**ADDENDUM NO. 1****August 19, 2022**

**RE: Franklin Police Department  
177 West Cedar Street  
Cincinnati, OH 45238  
Project No. 20080**

**1. Drawing Sheet – C-106 Site Utility Plan**

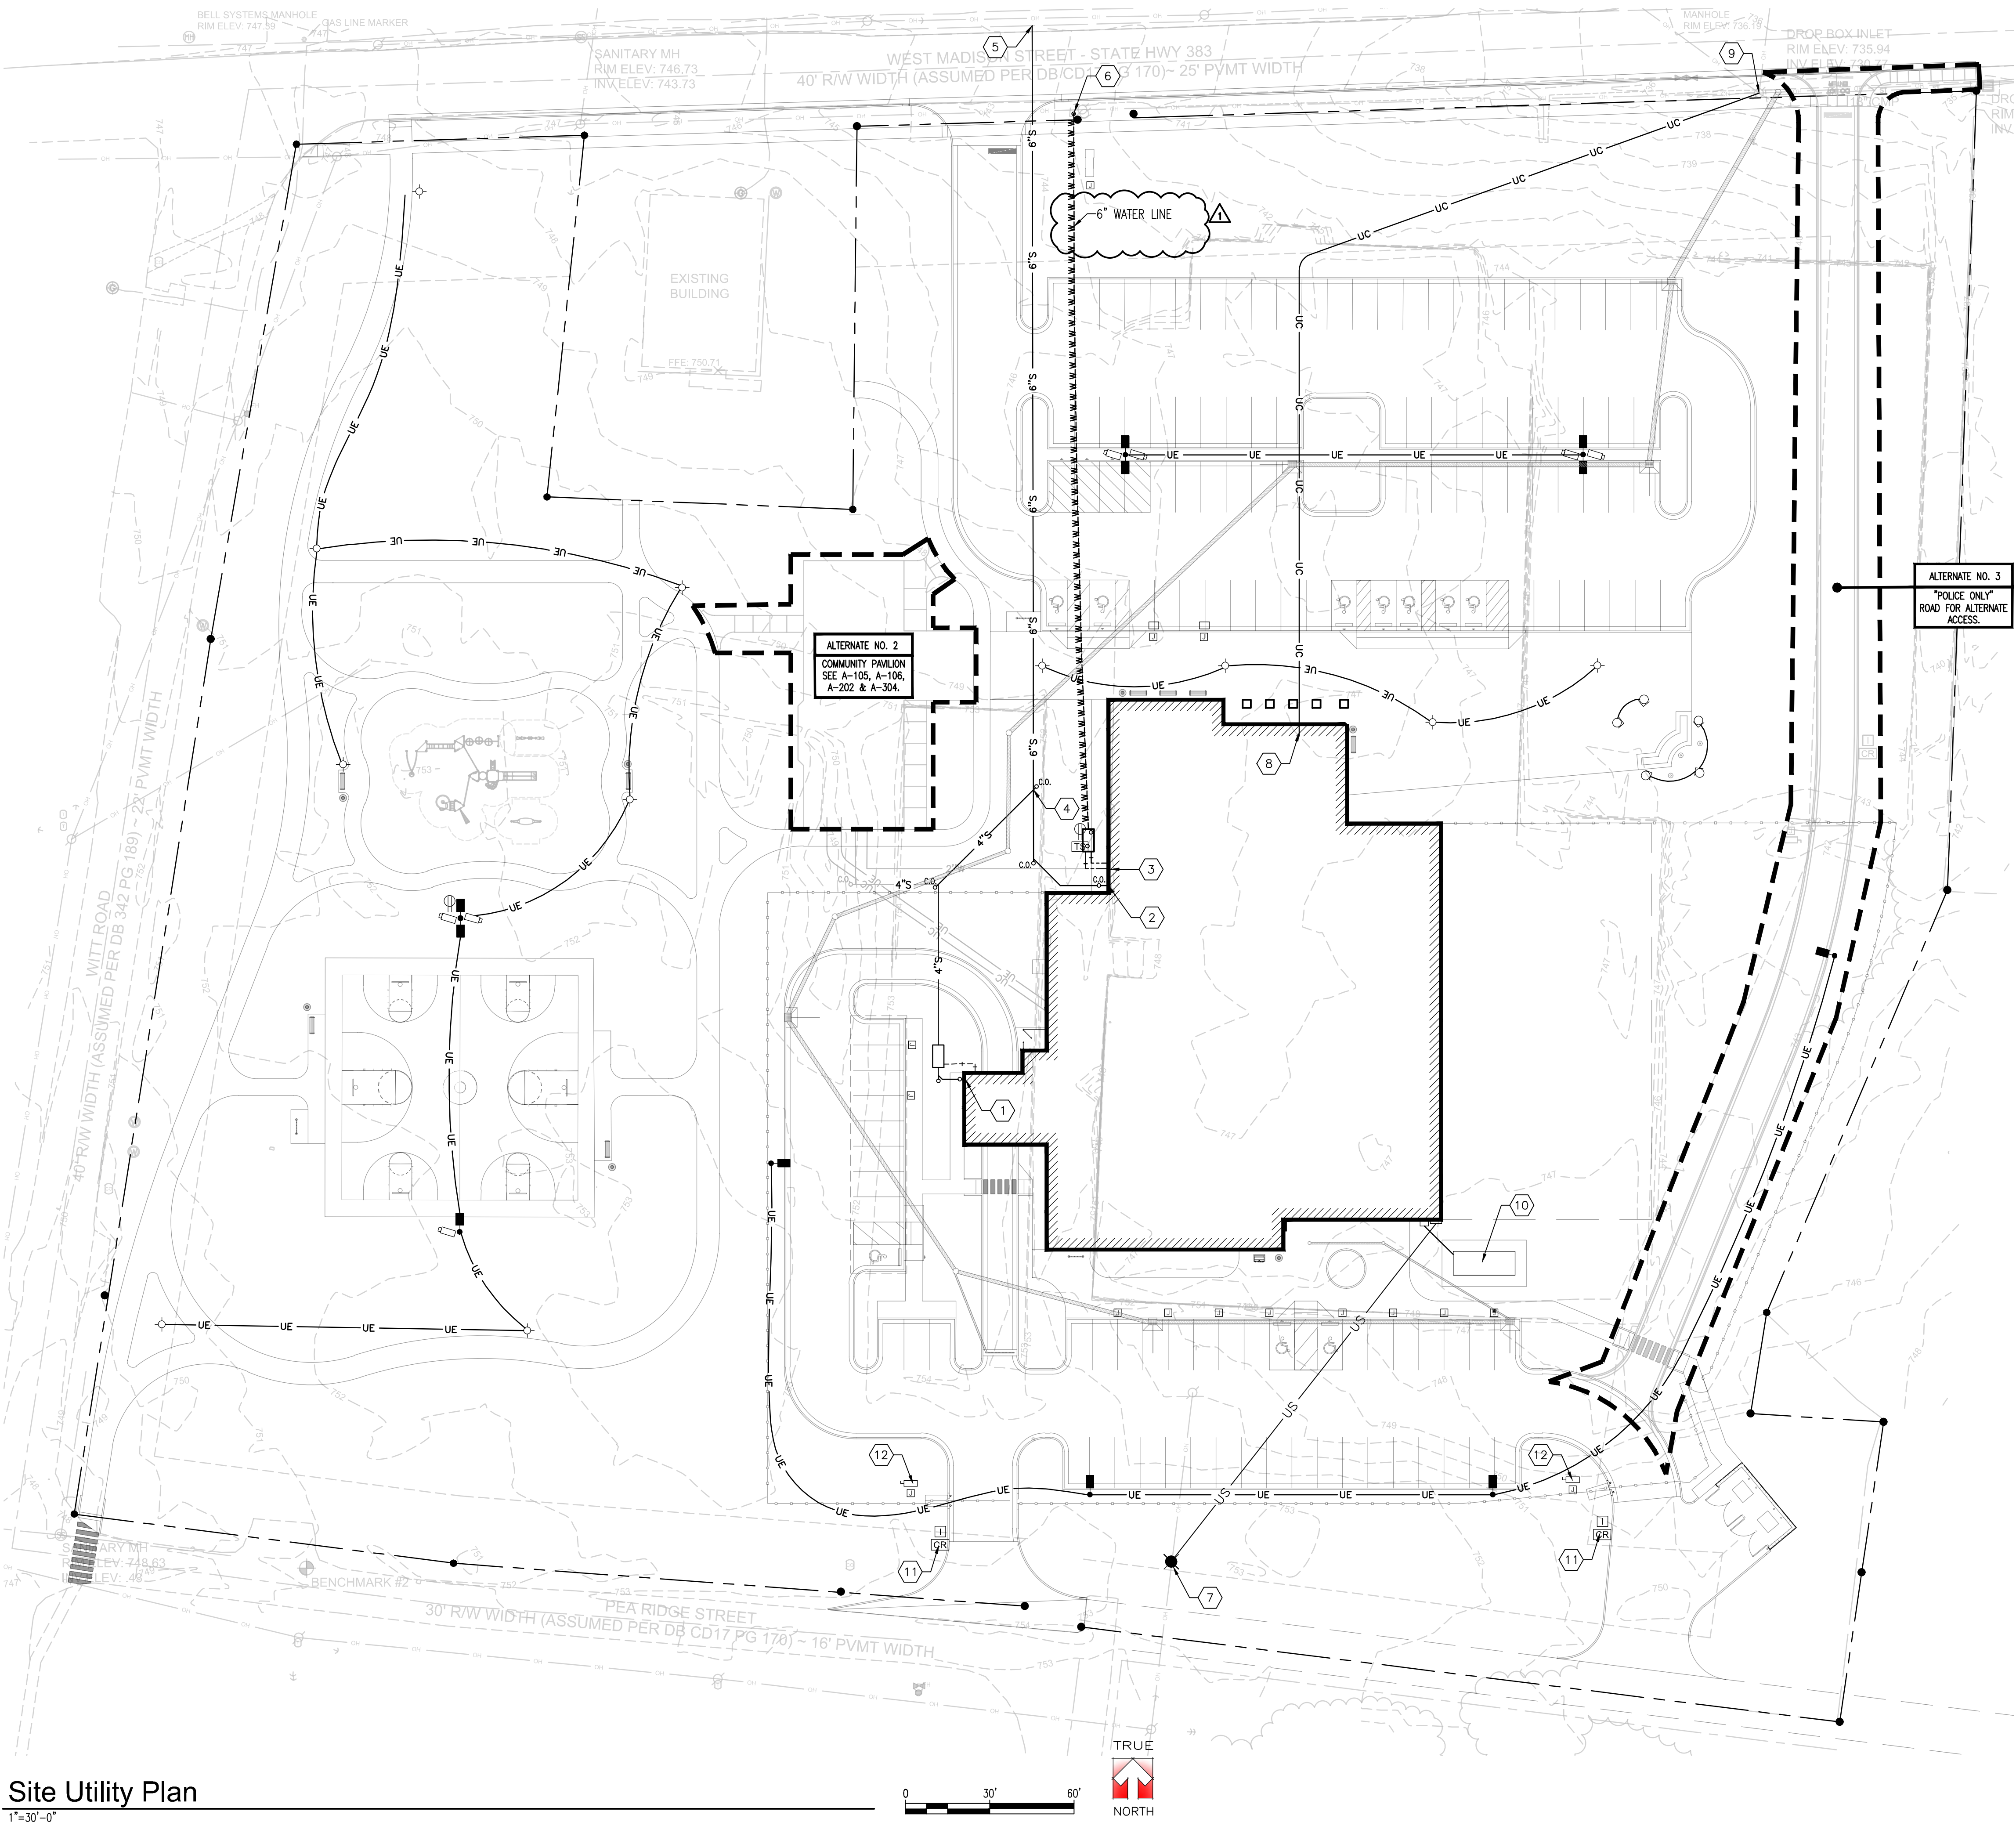
- A. See revised sheet for modified water line to 6".
